Secure Training Facility, Cardiff

Stage 3 report

11/01/2018 Revision 7

ACOUSTICS

Figure A2 – First Floor Acoustic Mark Up

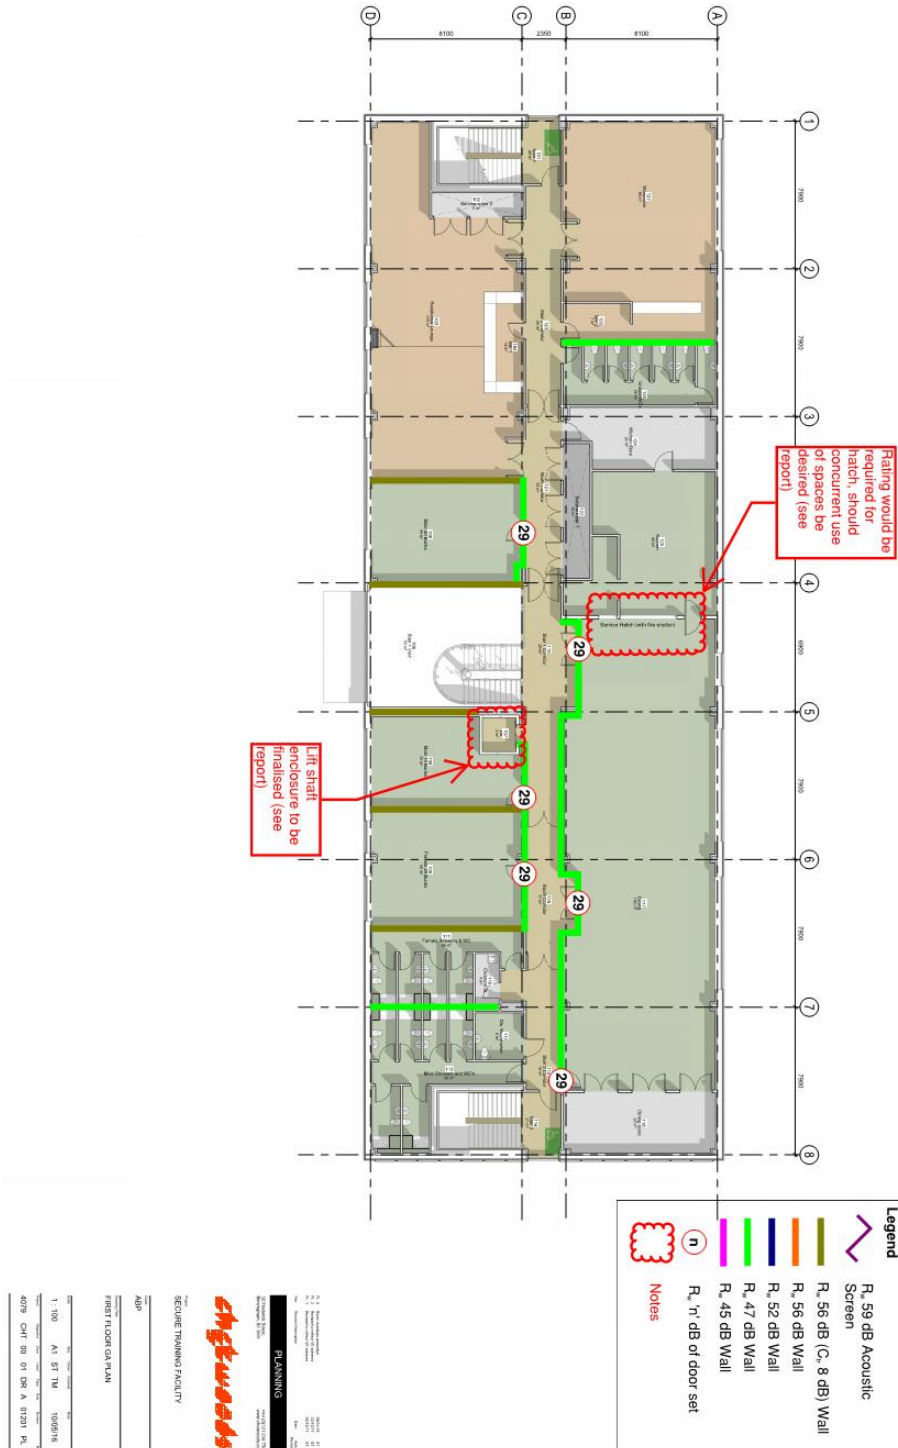
The mark-ups in Appendix A provide the  $R_w$  values necessary for partitions and doors to achieve the  $D_{nT,w}$  criteria in Table 2.

Entrance doors to bunks should be rated at  $R_w$  29 dB. The walls adjacent to the doors have been rated at  $R_w$  47 dB to avoid over-specification as the door is the weak path. Minimum privacy requirements should be met from the corridor to the bunk areas.

Figure A3 – Second Floor Acoustic Mark Up

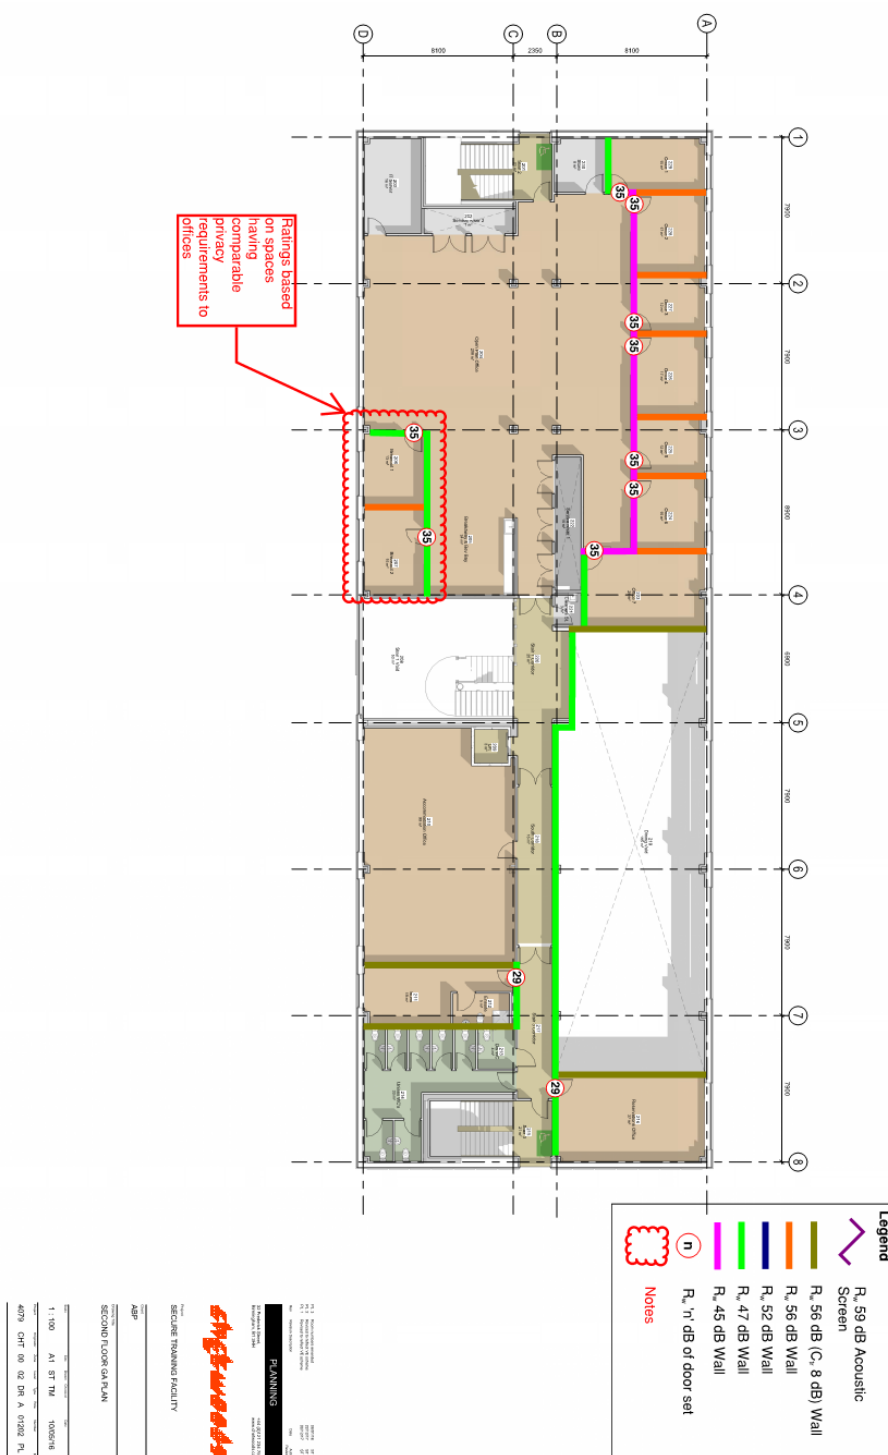
The Dining Room is a double height space, so the mass barrier ceiling has been continued at second floor level. The Dining Room shares party walls with multi occupancy offices at second floor. The walls have been specified as the bedroom party walls,  $R_w + C_{tr}$  48 dB, the predicted noise intrusion when the Dining Room is in use as a Drill Hall with an operational noise level of 80 dB  $L_{Aeq,T}$  is around 40 dB  $L_{Aeq,T}$ , the activity will be audible in these offices when this occurs.

Figure A4 – Third Floor Acoustic Mark Up

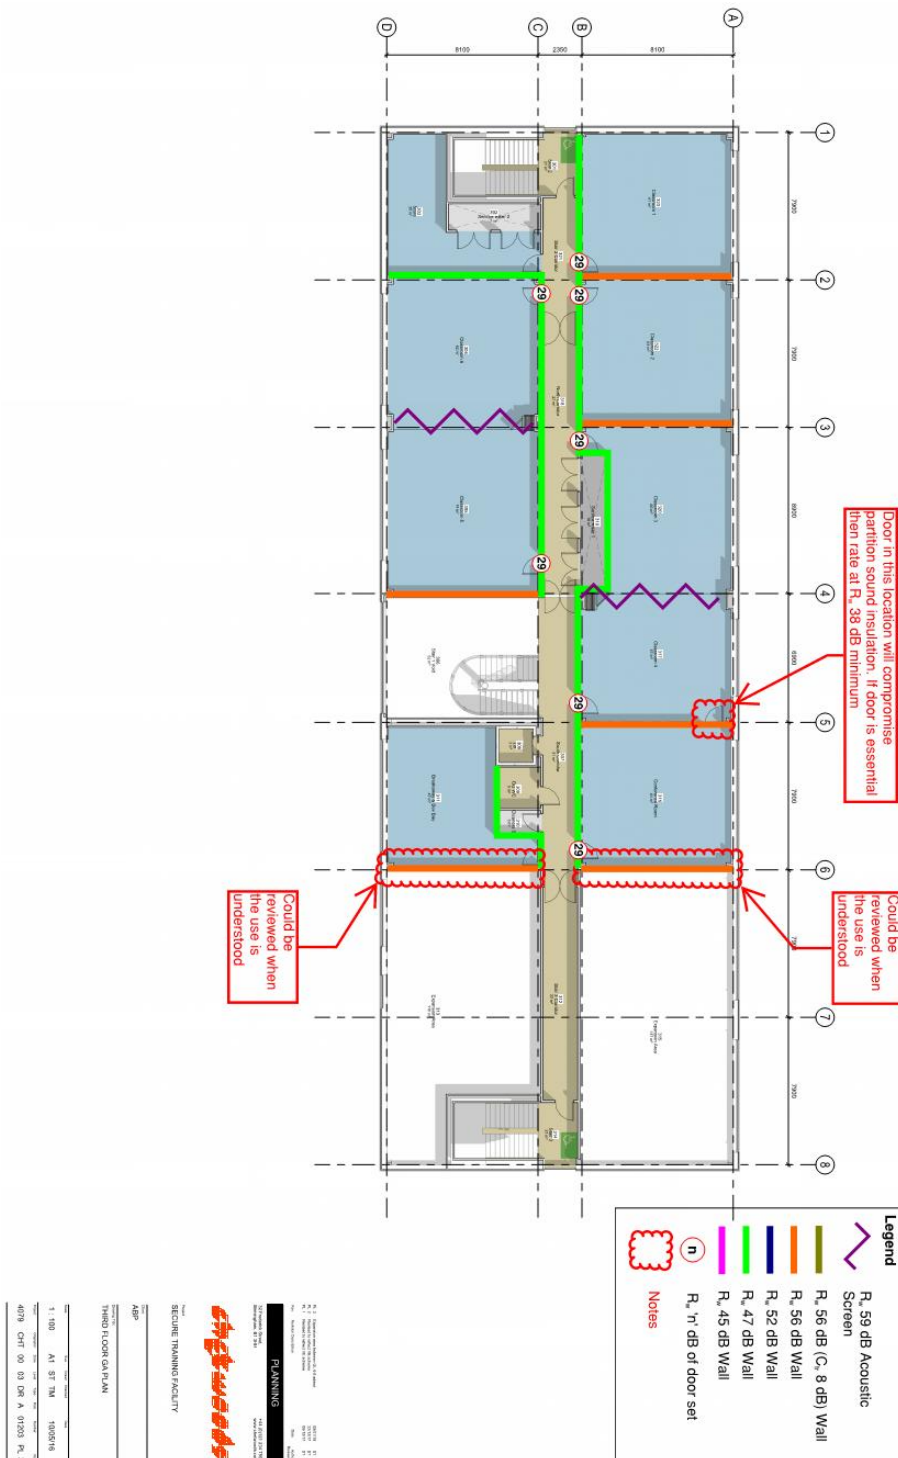
Plant is proposed to be located above the Third Floor accommodation, the lightweight roof system, has a low sound insulation value, on this basis the noisier plant should be located over stair void area and corridor. The ceiling should achieve at least  $D_{nc,w}$  35 dB throughout this level. A final review will be required of all plant at this level at the next design stage to ensure the stated criteria are not exceeded. All plant will require significant vibration isolation measures.

Figure B1 – Higher Performance Ceiling Constructions

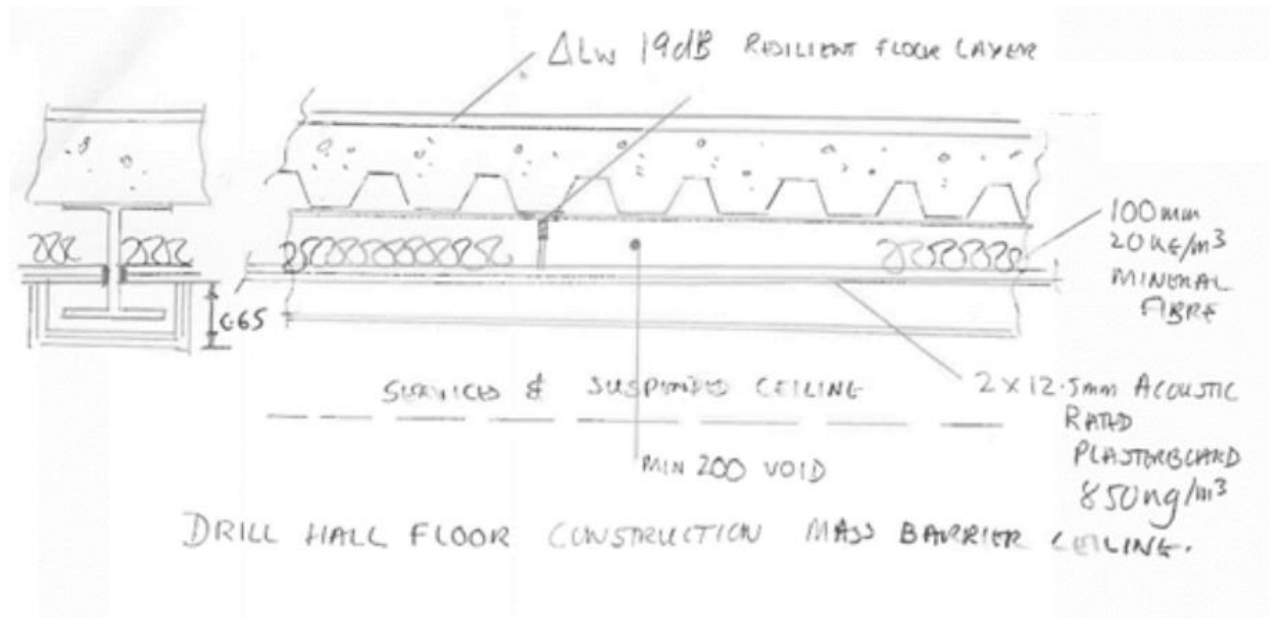
$D_{nT,w}$  60 dB is the highest practical sound insulation that can be achieved with the proposed separating floor with a mass barrier ceiling as below, maintaining the same level. In order to achieve this the following construction is recommended:

Mass Barrier Ceiling Construction (230mm zone)

- ▶ 100mm mineral fibre quilt 20kg/m<sup>3</sup>
- ▶ Two layers 12.5mm acoustic rated plasterboard
- ▶ Services zone and ceiling beneath

Appendix B provides visual depictions of these constructions. Appendix C shows where these mass barrier ceilings should be located.
